# Section 42A Officer's Report

**Stream #3:** Residential and Rural

**Subjects:** Residential Zones

**Prepared by:** Kate Pascall

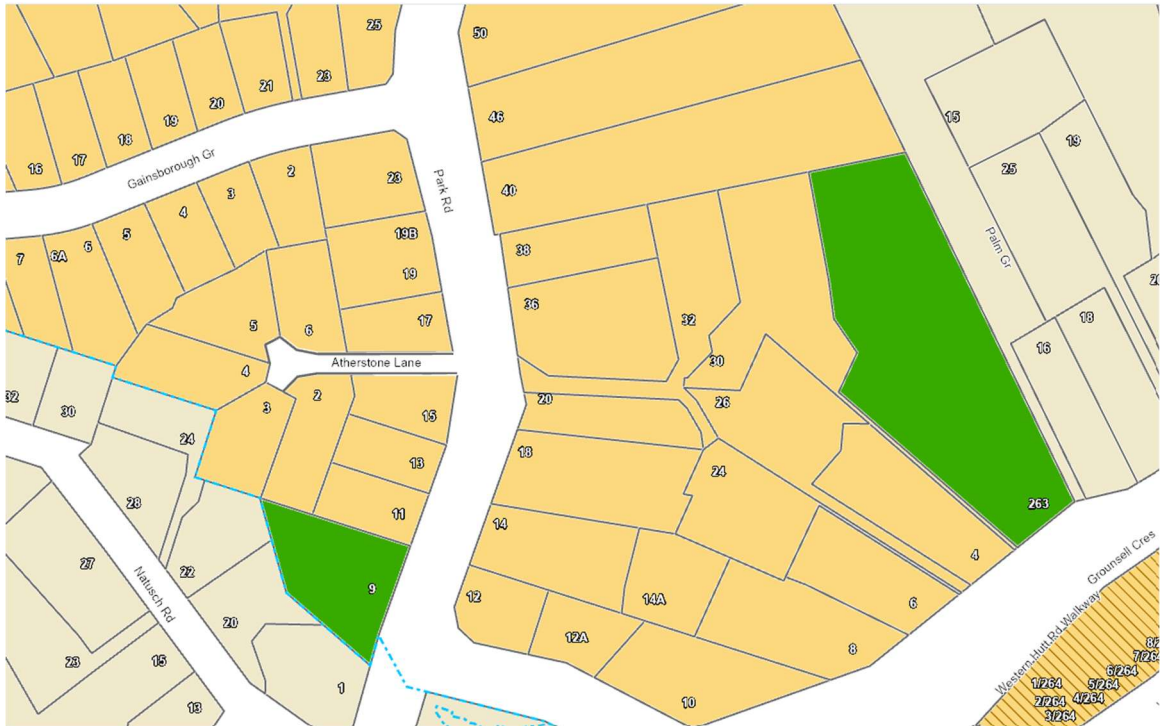
- (461) Argosy Property No.1 Limited [237.58] opposes the MRZ between Randwick Road, Waione Street and Commercial/Industrial/Open Space zones,

including Tirangi Road, Pitt Street, Pirie Crescent, Croft Grove, Okoutu Lane (see original submission for map). This submitter seeks that the planning maps are amended to place the area of MRZ on the west side of Randwick Road within the HRZ (see original submission for map). Reasons include consistency with 39 and 51 Randwick Road.

Figure 2 Revised Indicative Zoning Layout sought for 452 Cambridge Terrace (supplied by submitter)

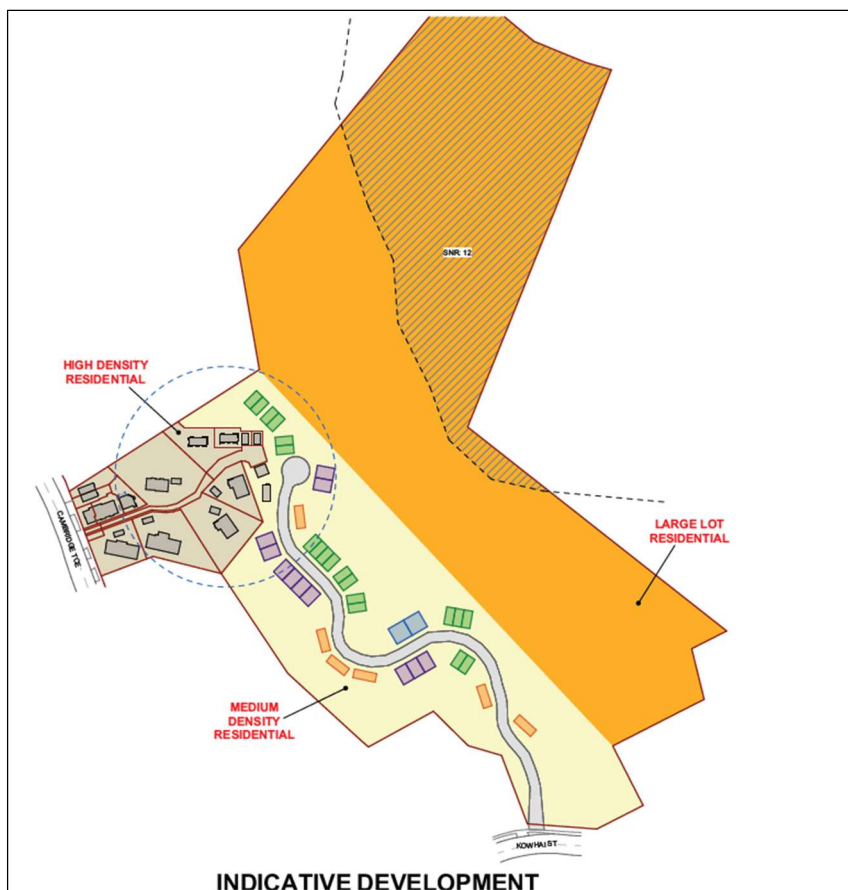
- (512) Lucas Land Surveys Limited seek the rezoning of 443 Cambridge Terrace and 452 Cambridge Terrace to Medium Density Residential from Large Lot Residential Zone. Design Network Architecture and John Havler seek the rezoning of the adjoining site at 452 Cambridge Terrace to Medium Density Residential. I note the ODP and PDP maps show 443 Cambridge Terrace is already zoned High Density Residential. In terms of 452 Cambridge Terrace, the site is zoned Hill Residential Activity Area under the ODP.

- (513) The relief sought in the original submissions is for the entire site at 452 Cambridge Terrace to be rezoned. The site has an area of approximately 7.3 hectares and is an elevated site. I understand from discussions with the submitters that they have revised their plans for the development of the site for medium density development, following assessment of the site constraints such as slope and vegetation cover. It is noted that part of the site is within SNR: 12 Eastern Hills Bush. The submitter has therefore revised their relief sought to retain that portion of the site within SNR:12 (plus some additional land outside that overlay) as LLRZ, and to rezone the lower part of the site, outside of the SNR overlay, to MRZ. This indicative zoning layout is shown in below in **Error! Reference source not found..**

- (514) I also note the majority of the site is subject to the Slope Assessment Overlay, which will trigger a geotechnical assessment for any future development of the site.

Figure 3 LLRZ properties on Holborn Drive

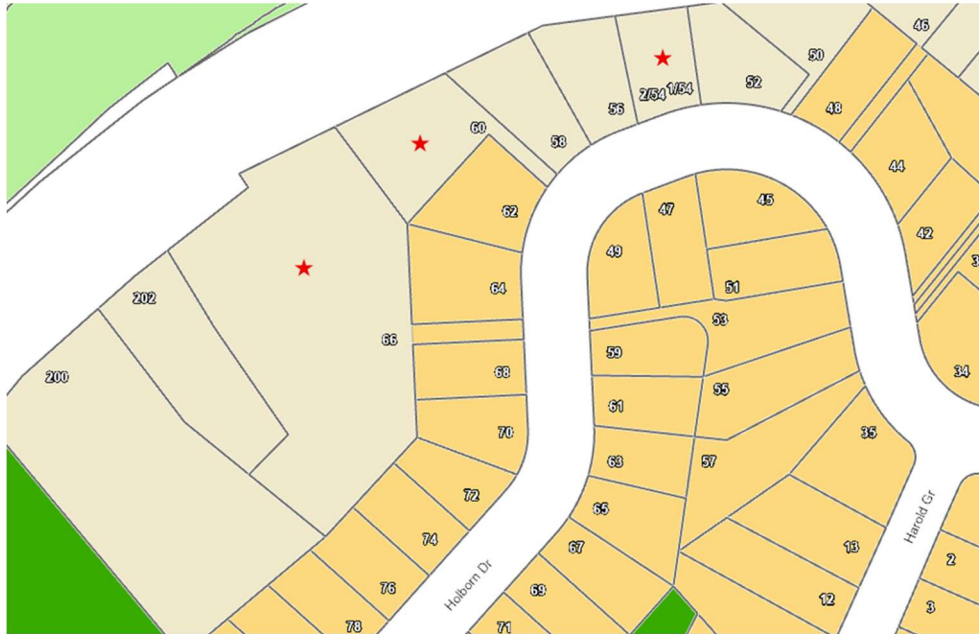
(523) Tim Phillips [64.1], Carleen Richards [117.1] and Rachel and James Prier [300.1], seek the rezoning of their properties on Holborn Drive (being 60, 1/54, and 66 respectively) from LLRZ to MRZ. I have reviewed these requests in terms of the criteria the Council has applied to identify locations for the LLRZ and the MRZ. While these properties generally meet the MRZ criteria, particularly in terms of access and three waters connections, I note these properties are within a section of Holborn Drive that is zoned LLRZ i.e.

adjoining properties are LLRZ, as shown in Figure 3 . No submissions have been received to rezone the block in its entirety, such that rezoning individual sites to MRZ would result in an inconsistent zoning pattern which may create unintended consequences for the adjoining properties that remain as LLRZ.

- (524) In my opinion, a consolidated zoning pattern that supports general consistency in built form is preferable to an ad hoc approach of enabling greater density on individual sites within a predominantly low-density environment. On this basis, I recommend rejecting the relief sought and retaining the LLRZ at 1/54, 60, and 66 Holborn Drive.

Figure 5 Properties on lower Korokoro slopes recommended to retain MRZ

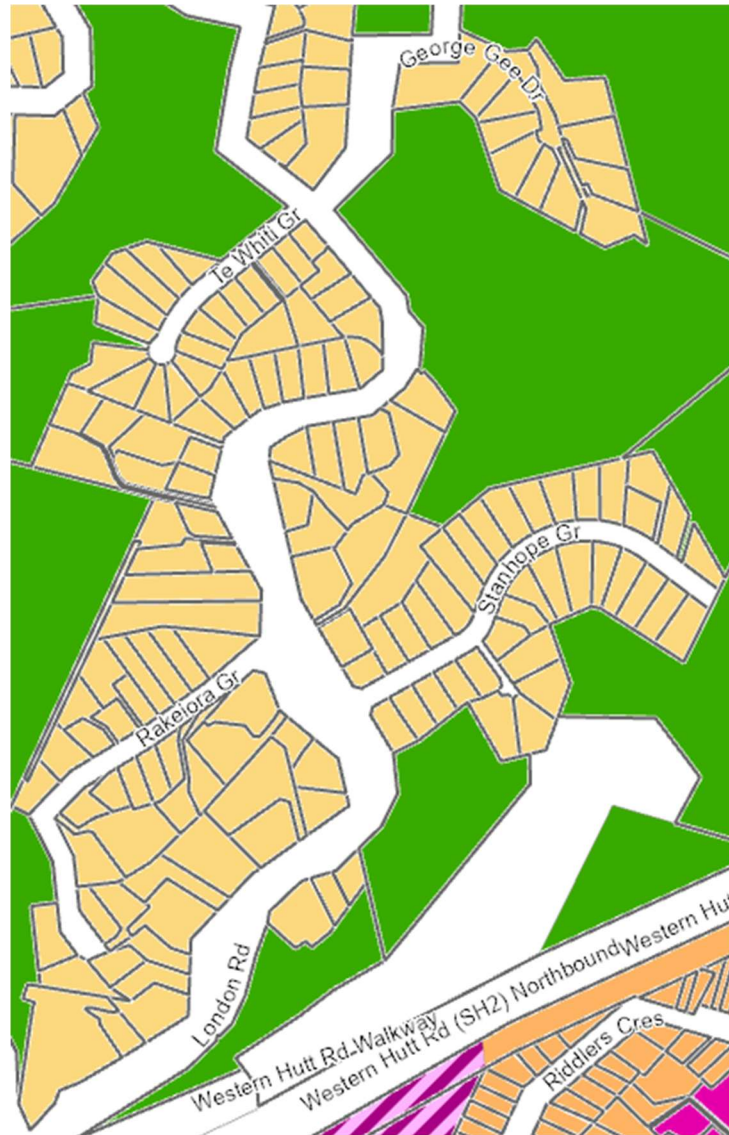
- the MRZ should be retained for properties on London Road, from the intersection with Korokoro Road to George Dee Drive, including Rakeiora Gr, Stanhope Gr, Te Whiti Gr & George Gee Dr shown in Figure 5 below.

(554) Accordingly, I recommend accepting in part the relief sought by Michael Stewart [481.1], and rejecting the relief sought by Rebecca Leask et al [472.1, 472.2 and 472.3] and Lorraine Mansfield [216.1 and 216.2].

Figure 7 Area on Randwick Road proposed for rezoning from MRZ to HRZ by Argosy Property No.1

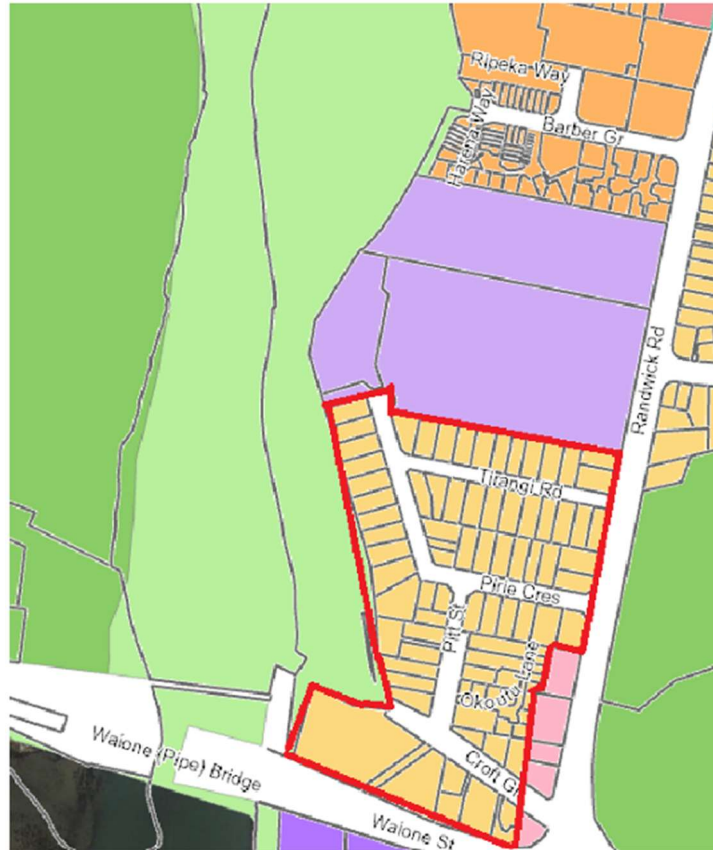
- (555) Figure 7 is rezoned from MRZ to HRZ, due to inconsistency with the zoning of 39 and 51 Randwick Road:

- (556) This area is located outside of the walkable catchments for HRZ that the Council applied through PC56 in accordance with Policy 3 of the NPS-UD. As such, the MRZ was applied to these properties.
